SEWAGE DISPOSAL SYSTEM

MARYLAND STATE DEPARTMENT OF HEALTH

A REPAIR

SUBDIVISION \_\_\_\_\_ ROAD 13483 Brighton Dam LOT 9

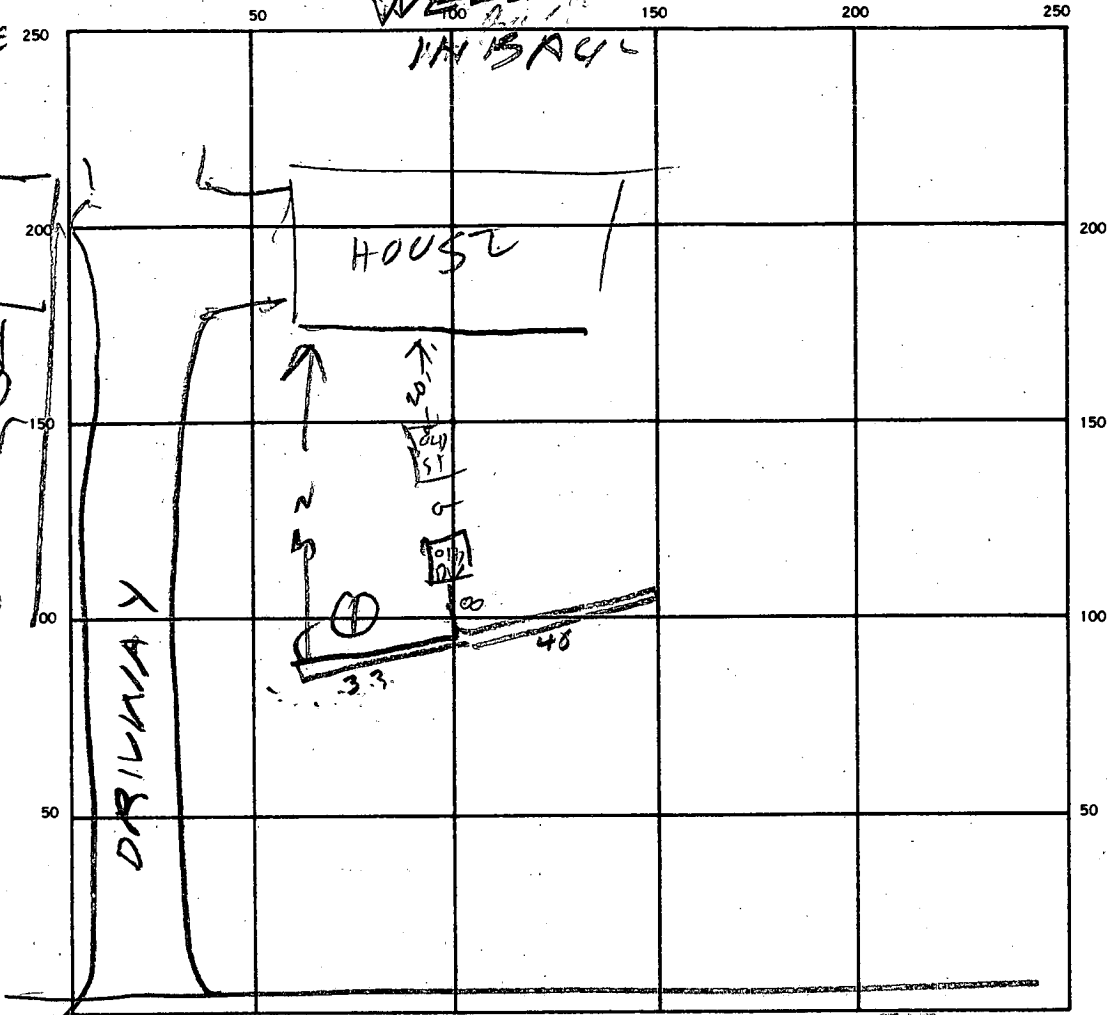
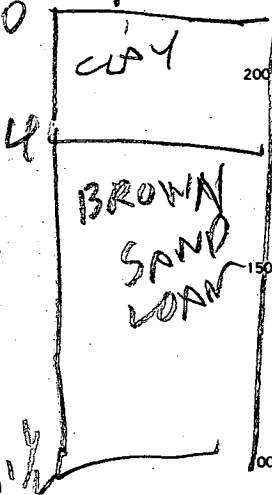
REMARKS 5/16/88 - ADD ANOTHER LOAD OF STONE & COVER TRENCH. SOIL VERY POROUS. SEE VISUAL HOLE  
5/16/88 - ADDITIONAL STONE ADD'D
